DOCUMENT 00 90 00
ADDENDUM

ADDENDUM NO. [2] **Date: October 29, 2020**

RE: SOUTHWEST WISCONSIN TECHNICAL COLLEGE
BUILDING 400 LECTURE HALL
1800 BRONSON BLVD
FENNIMORE, WI
BID NUMBER: 2021-02

1 HVAC PIPING REMODEL PLAN

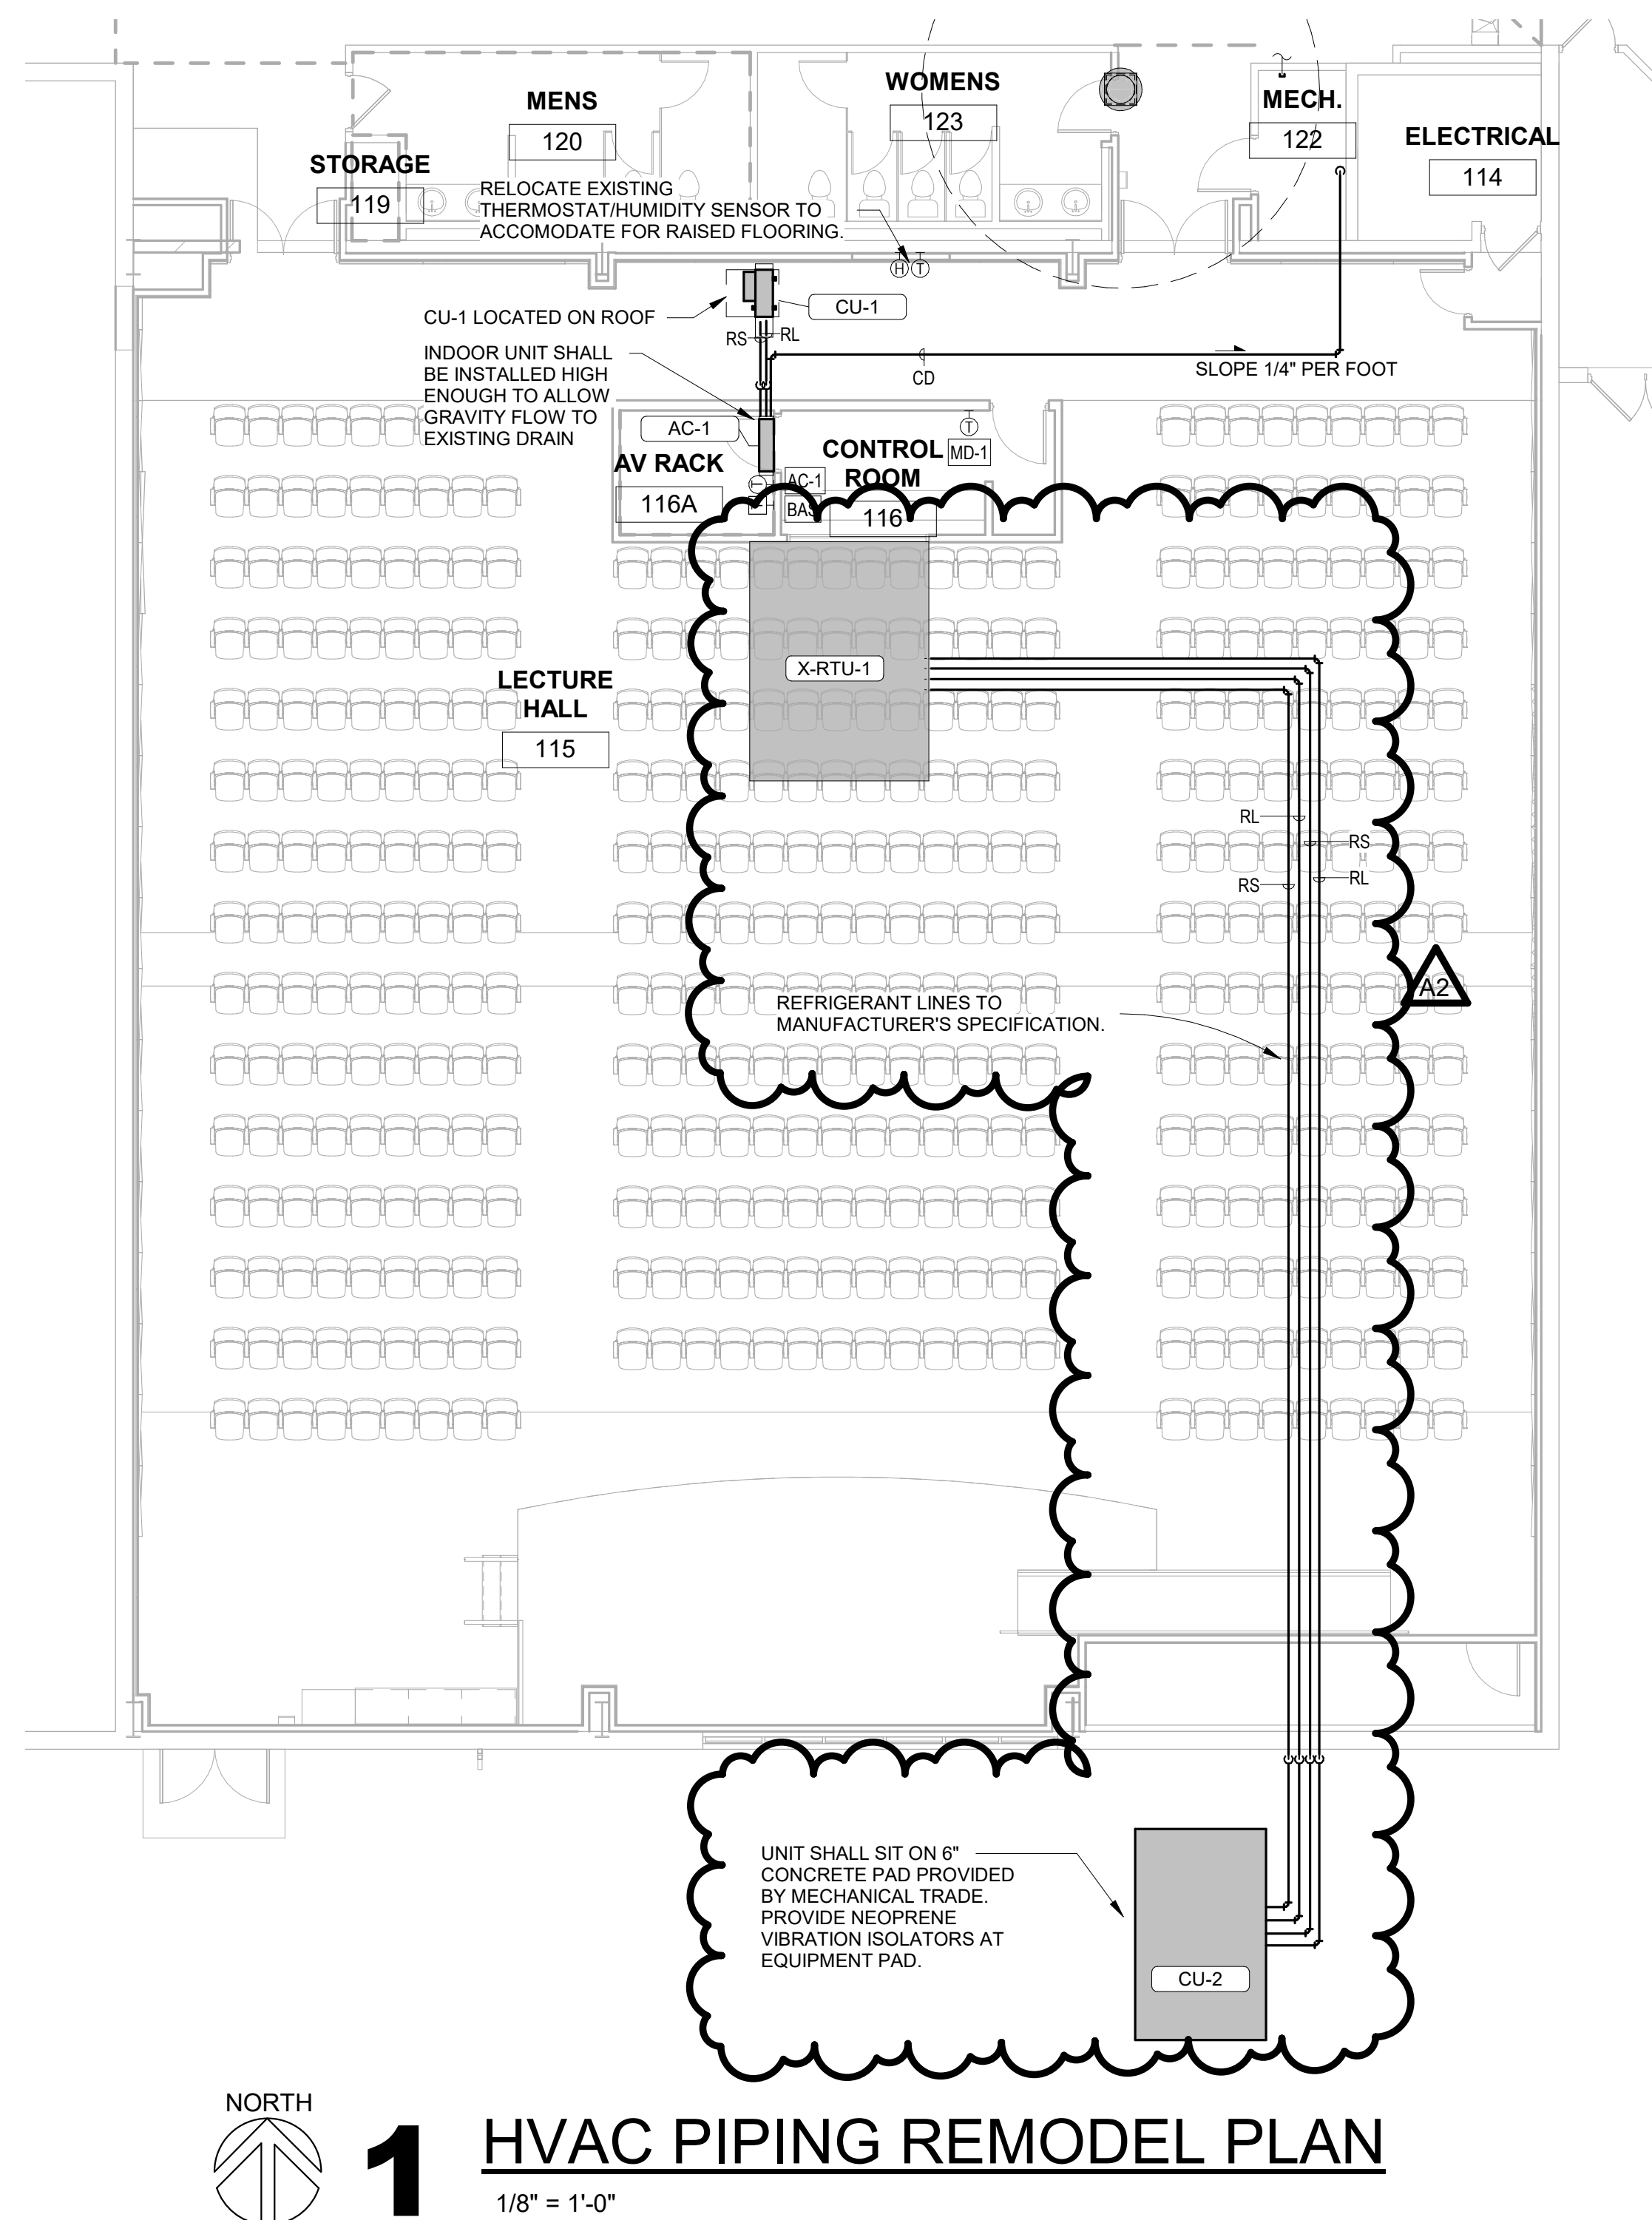
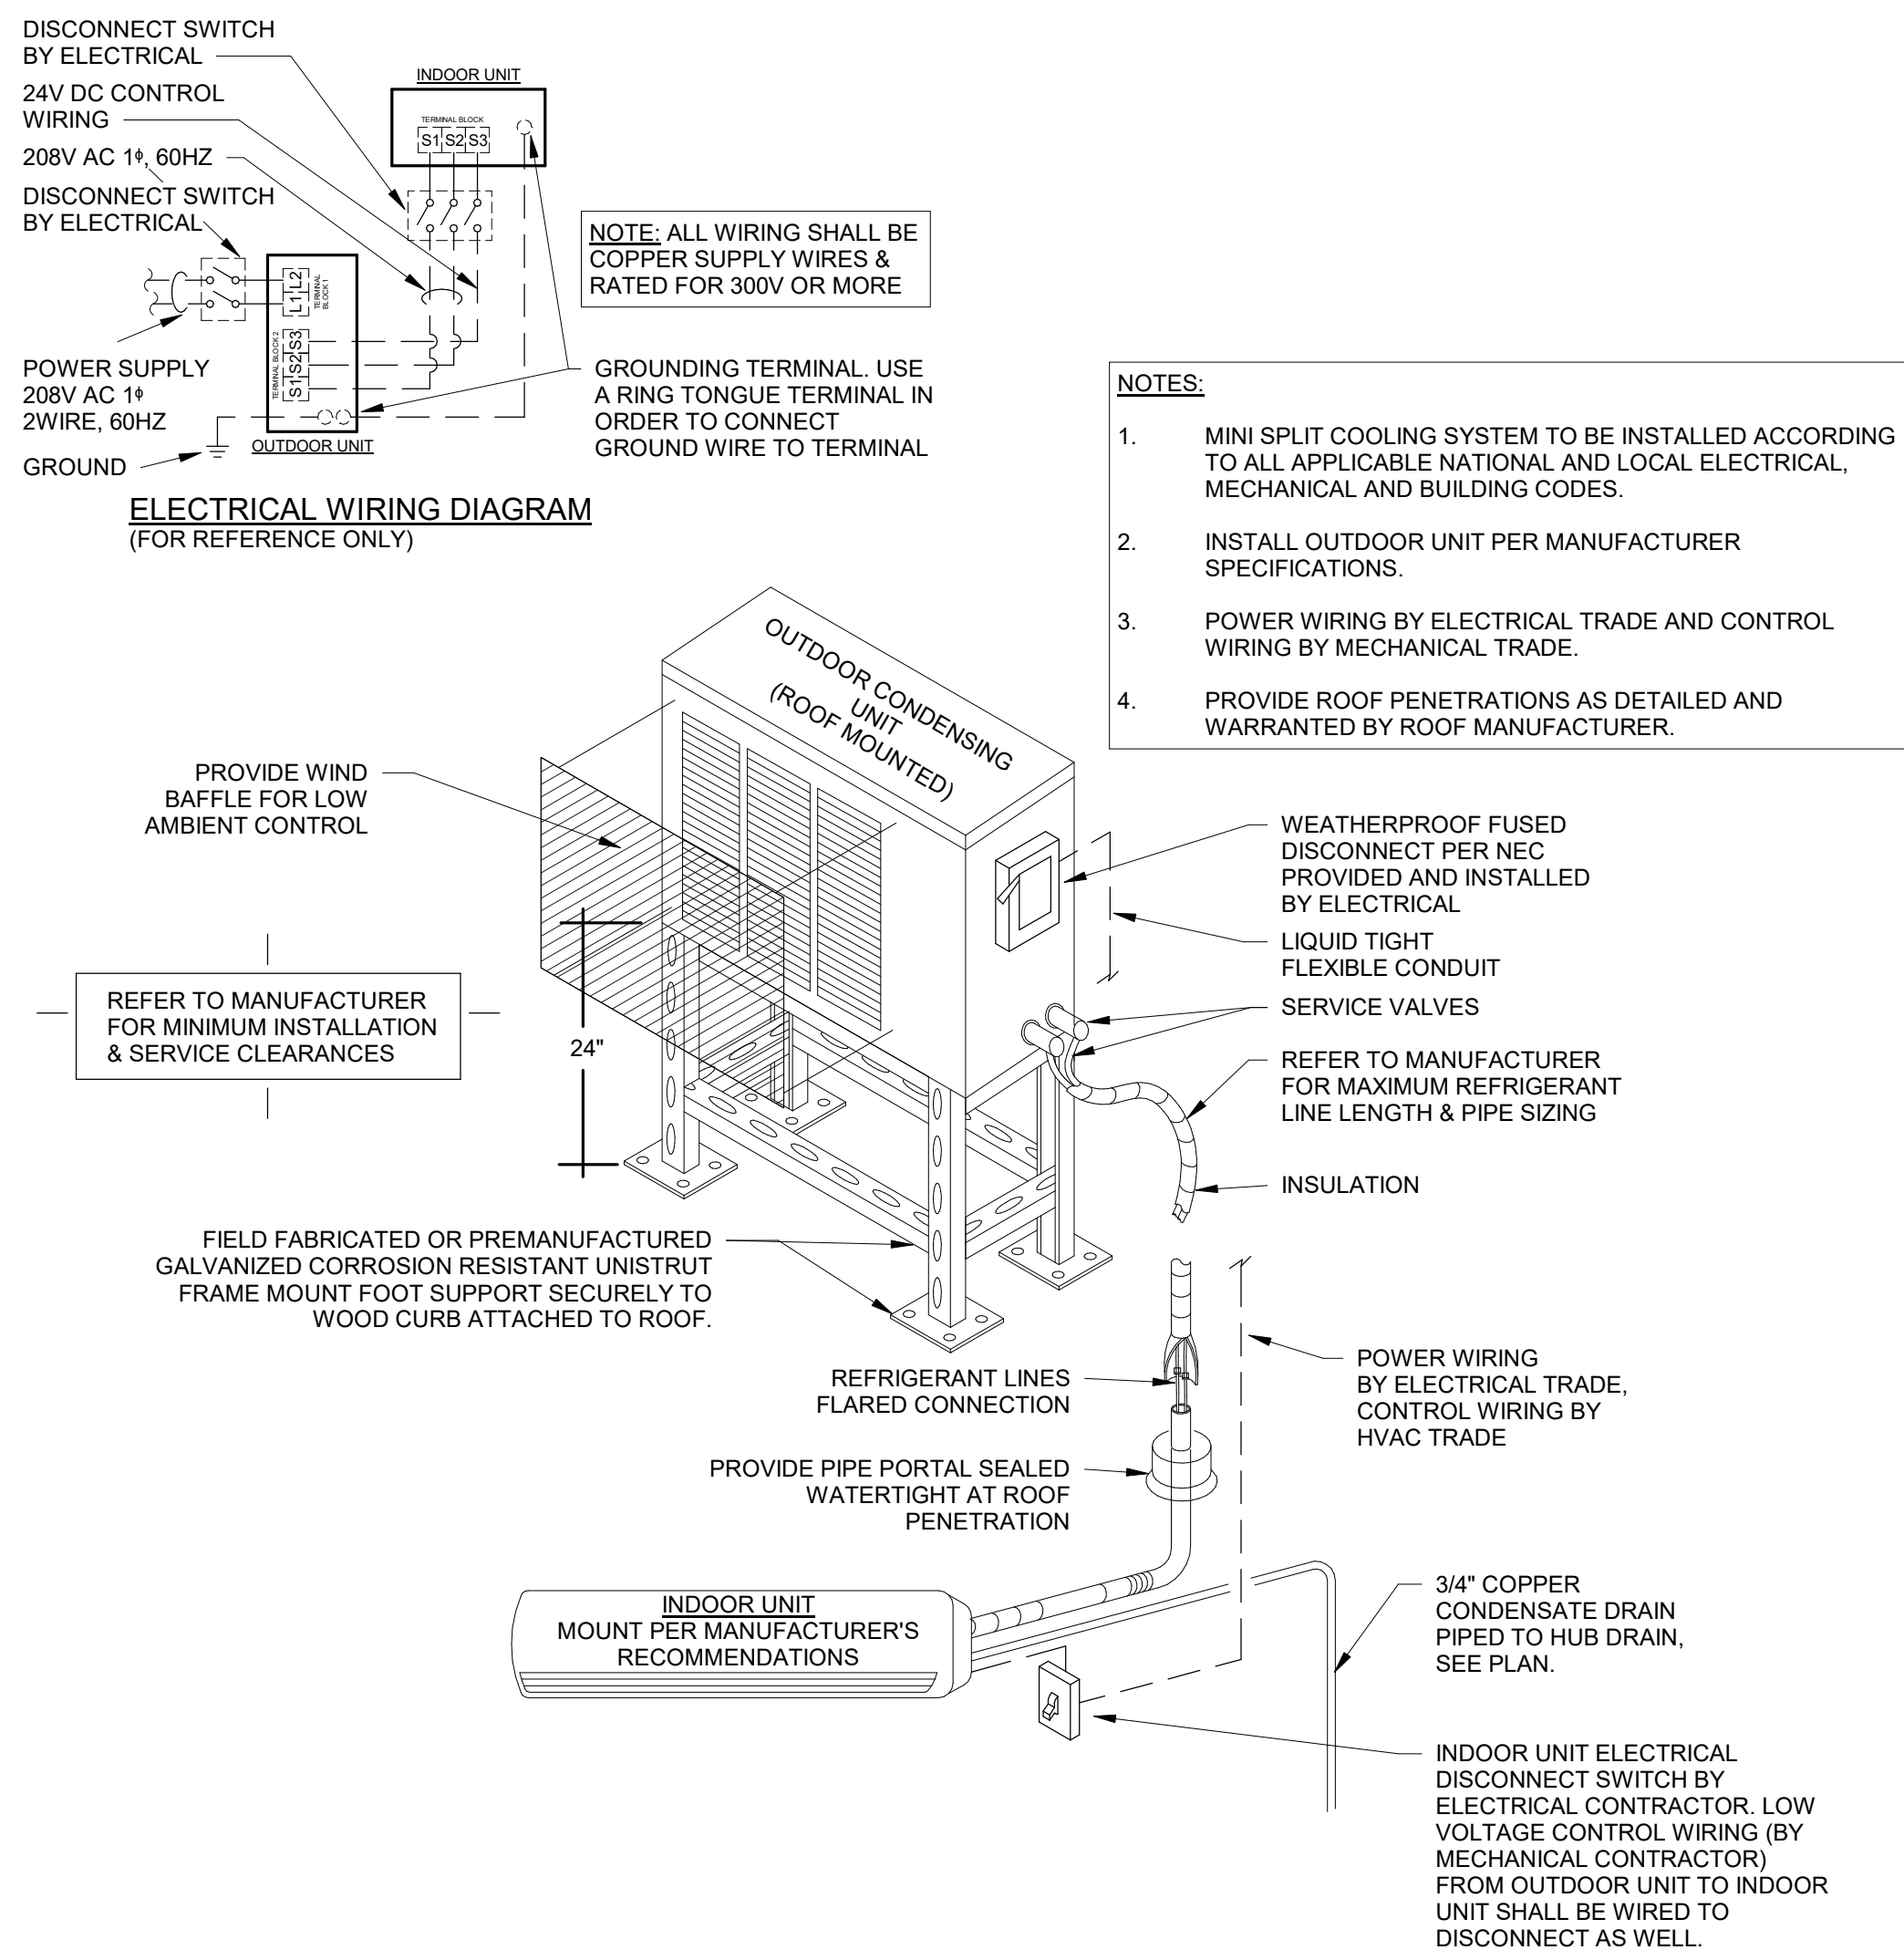
5. Sheet M101 HVAC PIPING REMODEL PLAN 30 x 42 attached hereto
 - a. Add Drawing attached hereto as part of Contract Documents.
 - b. Added condensing unit CU-2 and associated refrigerant piping.

- c. Revised Air Cooled Condensing Unit Schedule to include CU-2.
 - d. Revised Air Cooled Condensing Unit Schedule to show CU-1 model number change from “PUY-A30NKA7(-BS)” to “PUY-A18NKA7(-BS)”.

- e. Refrigerant piping running between air handling unit cooling coil and air-cooled condenser shall be per 23 07 19 and have outdoor pipe insulation jacketing per 23 07 19 section.
